## JOINT REGIONAL PLANNING PANEL (Sydney East Region)

<b>JRPP No</b>	2014SYE052
<b>DA Number</b>	DA-2014/335
<b>Local Government Area</b>	ROCKDALE
<b>Proposed Development</b>	Demolition of existing structures and construction of 2 x eight (8) storey residential flat buildings with rooftop terrace areas, comprising 175 residential units and basement parking
<b>Street Address</b>	40-50 Arncliffe Street Wolli Creek
<b>Applicant/Owner</b>	Urbanlink Pty Ltd
<b>Number of Submissions</b>	One (1)
<b>Regional Development Criteria (Schedule 4A of the Act)</b>	Development that has a capital investment value of more than \$20 million.
<b>List of All Relevant s79C(1)(a) Matters</b>	<p>List all of the relevant environmental planning instruments s79C(1)(a)(i);</p> <ul style="list-style-type: none"> <li>• SEPP – 55 – Remediation of Land</li> <li>• SEPP 65 – Design Quality of Residential Flat Development</li> <li>• Residential Flat Design Code</li> <li>• SEPP Infrastructure 2007</li> <li>• Rockdale Local Environmental Plan 2011</li> </ul> <p>List any proposed instrument that is or has been the subject of public consultation under the Act and that has been notified to the consent authority: s79C(1)

Figure 4 – Laundry / Storage example

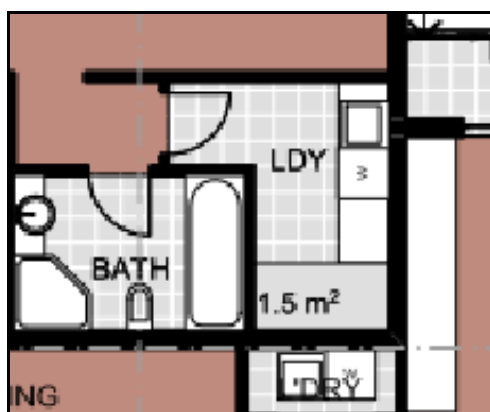
- c. Amended plans indicate the provision of separate storage cupboards within units, with a number of units comprising a shared laundry / storage area as follows.*

The design of the above provides for a generous laundry with specifically allocated space for washing machines, dryers and cupboards for storage. This is satisfactory.

It is further noted that a number of units still do not appear to comprise internal unit storage i.e. A112, A103, B206, B407 etc. The proposal has been conditioned to ensure that storage is provided within all units as per the requirements of the RFDC.

Figure 5 – Ground level skylights to upper basement level

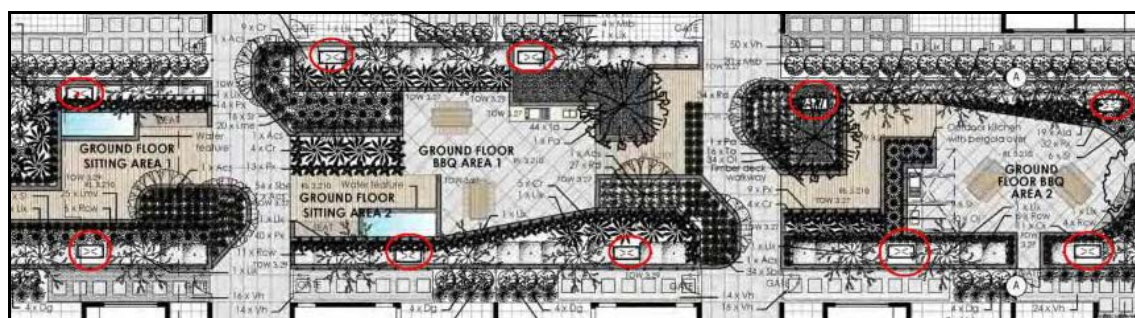
In respect of internal bathrooms, amended plans indicate the provision of windows where possible. It is noted that mechanical ventilation will be provided to bathrooms where it is not possible to provide a window.

Figure 6 – Road Network and Access

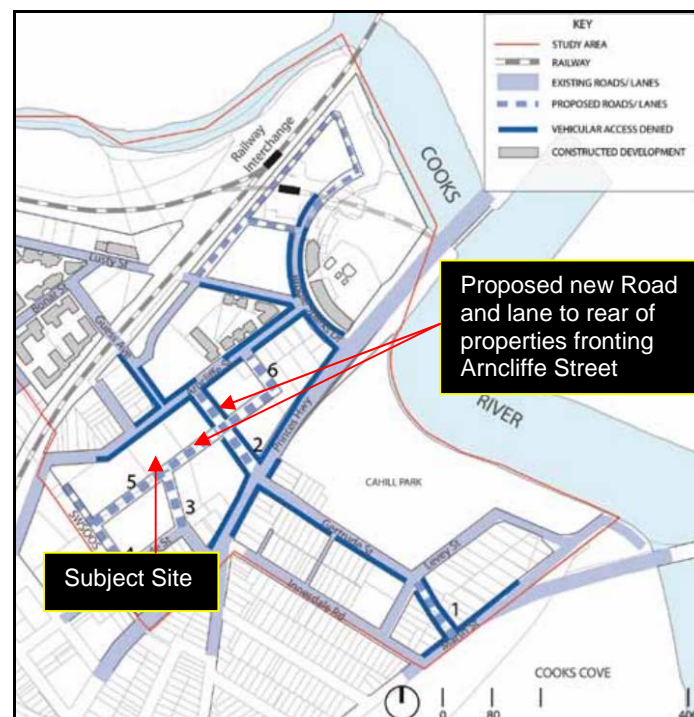
Part 7.1.5 – Road Network & Vehicular Access of DCP 2011, requires the proposal to be consistent with the road network and vehicular access location requirements as indicated below.

It is envisaged that a new road is to be created to the NE of the neighbouring site at 52 Arncliffe Street, which would subsequently allow for the creation of a new laneway along the rear of sites fronting onto Arncliffe Street.

The proposal is inconsistent with the above in regards to the location of the proposed vehicular access off Arncliffe Street. There is no alternative location to the rear of the site as existing at the present time as the above road and lanes have not been formed. As such vehicular access has been considered on its merits and variation to the above requirement and the provision of vehicular access from Arncliffe Street is satisfactory.
